HISTORIC AND DESIGN REVIEW COMMISSION

February 06, 2019

HDRC CASE NO: 2019-024
ADDRESS: 1201 E CROCKETT ST
LEGAL DESCRIPTION: NCB 1373 BLK 1 LOT W 77.4 FT OF 9 & 10
ZONING: MF-33, H
CITY COUNCIL DIST.: 2
DISTRICT: Dignowity Hill Historic District
APPLICANT: Nate Manfred/French and Michigan
OWNER: Keith Jones/JT Renovations
TYPE OF WORK: Amendments to previously approved materials
APPLICATION RECEIVED: January 18, 2019
60-DAY REVIEW: March 17, 2019

The applicant is requesting a Certificate of Appropriateness for approval to amend the previous scope of work from issued July 19, 2017, to instead feature the following:

Wood Window (Aluminum Clad Exterior)

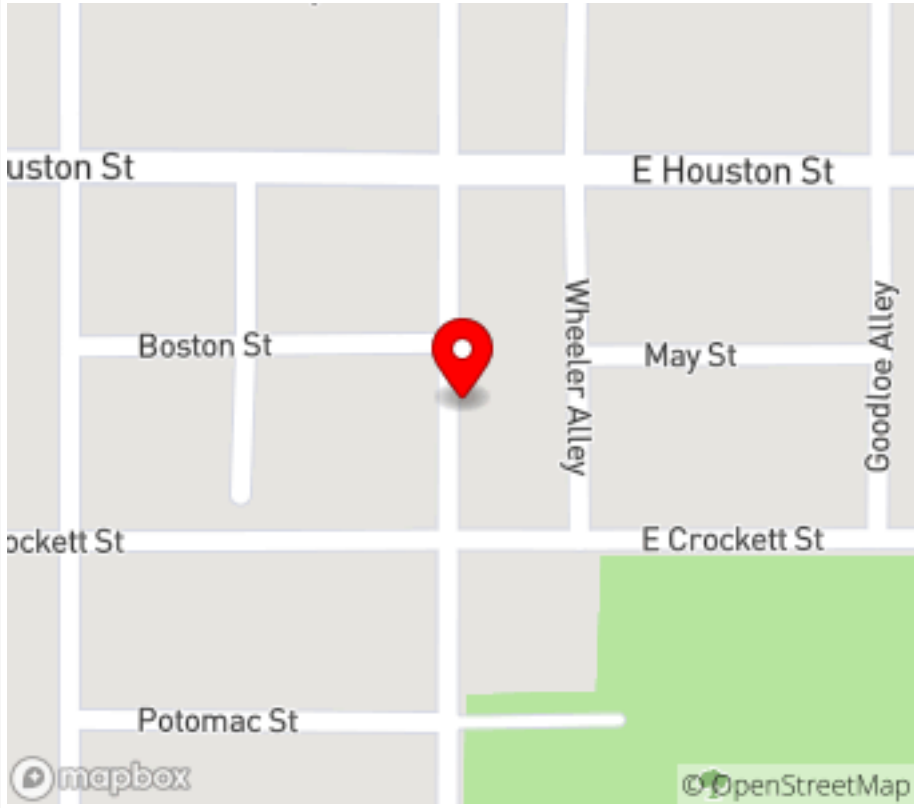
- e. WINDOW REPLACEMENT – The applicant has proposed to amend the previous approval to replace non-historic windows with wood windows to instead feature aluminum-clad wood window with faux divided lites. Per the Guidelines for Exterior Modifications and Alterations 6.B.iv. new windows are to match the historic or existing windows in terms of size, type, configuration, material, form, appearance, and detail when the original window are deteriorated beyond repair and 6.B.v. prohibiting the use of internal muntins sandwiched between layers of glass. While staff finds that the aluminum-clad wood window are an improvement upon the vinyl windows, the faux divided lites are consistent with the standard stipulations: *Meeting rails that are no taller than 1.25" and stiles no wider than 2.25". White manufacturer's color is not allowed, and color selection must be presented to staff. There should be a minimum of two inches in depth between the front face of the window trim and the front face of the top window sash. This must be accomplished by recessing the window sufficiently within the opening or with the installation of additional window trim to add thickness. Window trim must feature traditional dimensions and an architecturally appropriate sill detail. Window track components must be painted to match the window trim or concealed by a wood window screen set within the opening.*

- i. Replacement of non-historic windows may be wood or aluminum-clad wood that do not feature faux divided lites and meet the standard stipulations: *Meeting rails that are no taller than 1.25" and stiles no wider than 2.25". White manufacturer's color is not allowed, and color selection must be presented to staff. There should be a minimum of two inches in depth between the front face of the window trim and the front face of the top window sash. This must be accomplished by recessing the window sufficiently within the opening or with the installation of additional window trim to add thickness. Window trim must feature traditional dimensions and an architecturally appropriate sill detail. Window track components must be painted to match the window trim or concealed by a wood window screen set within the opening.*

STAFF PHOTOS
TAKEN JUNE 2018

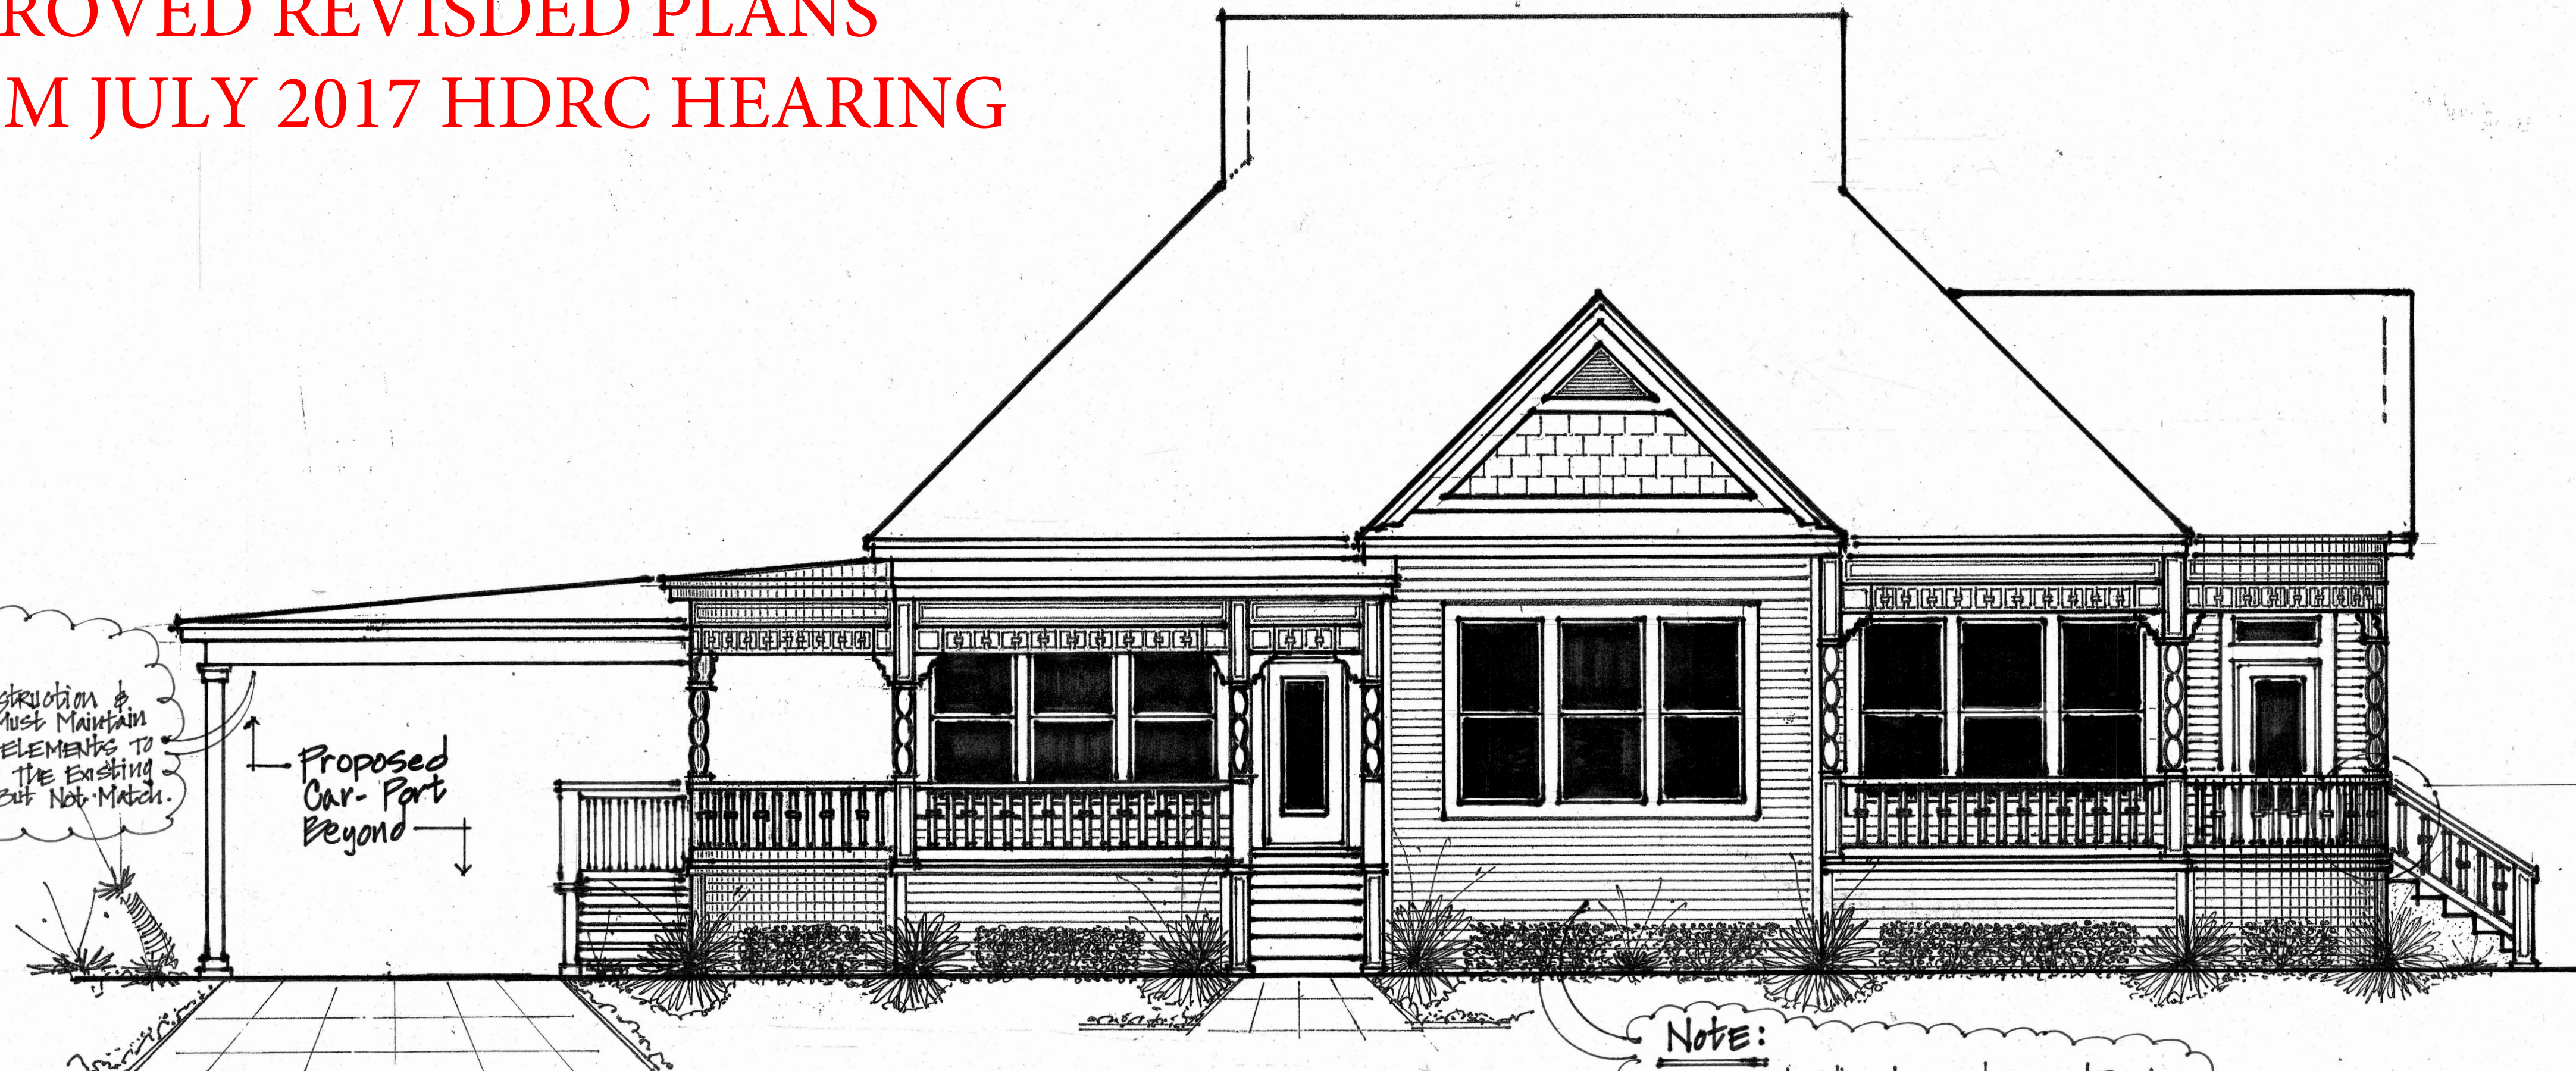
- d. WINDOW REMOVAL – The applicant has proposed to remove and enclose five windows: a set (2) of windows on the E Crockett facade and three (3) windows on the east side elevation. According to the applicant, these windows were removed by the previous owner. Staff finds that these windows were in place on June 2018. Per the Guidelines for Exterior Modifications and Alterations 6.A.i., historic windows and doors should be preserved in size and not filled in. Staff that that 5 window openings should be restored.

- ii. The 5 removed window should be restored to their original location and configuration; new windows should match the specifications noted in finding e.

APPROVED REVISED PLANS
FROM JULY 2017 HDRC HEARING

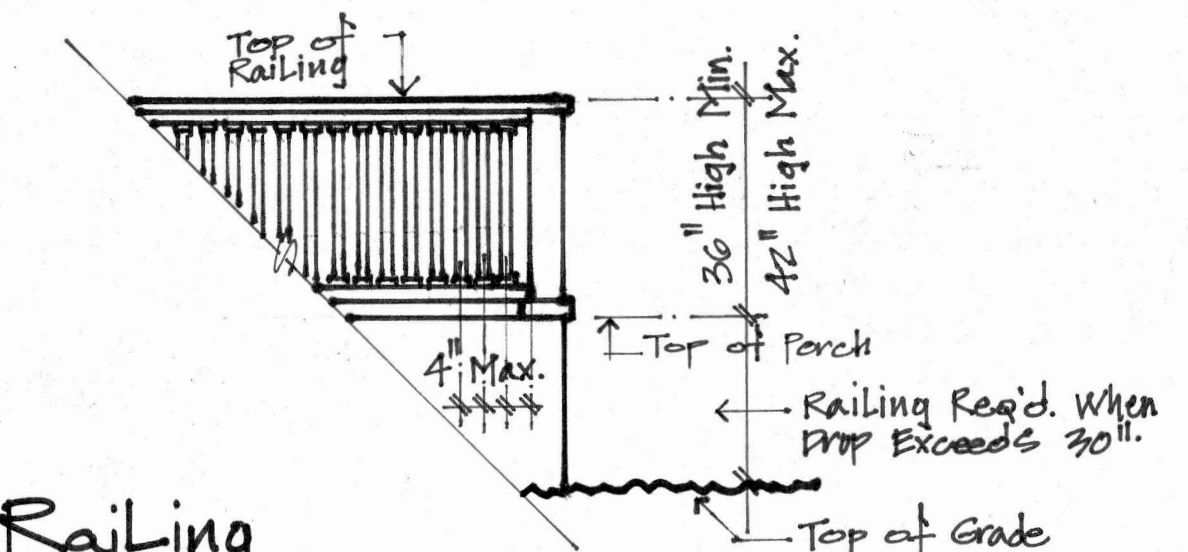
- f. PORCH – The applicant has proposed to install square cedar columns instead of the Queen Anne style turned columns, railing, and spindle work. Per the Guidelines for Exterior Modifications and Alterations 7.A.v., porches should be reconstructed based on accurate evidence of the original or be based on the architectural style of the house. Staff finds that these character defining features have remained in-place since at least 1994 through June 2018. A simplified contemporary interpretation of column replacements may be appropriate when the original features have been loss or unknown. However, staff finds that there is ample support to reconstruct the porch with the Queen Anne details as approved in July 2017.

- iii. The front porch should be reconstructed to match its historic Queen Anne style as depicted in photographs and the July 19, 2017, approved plan set.
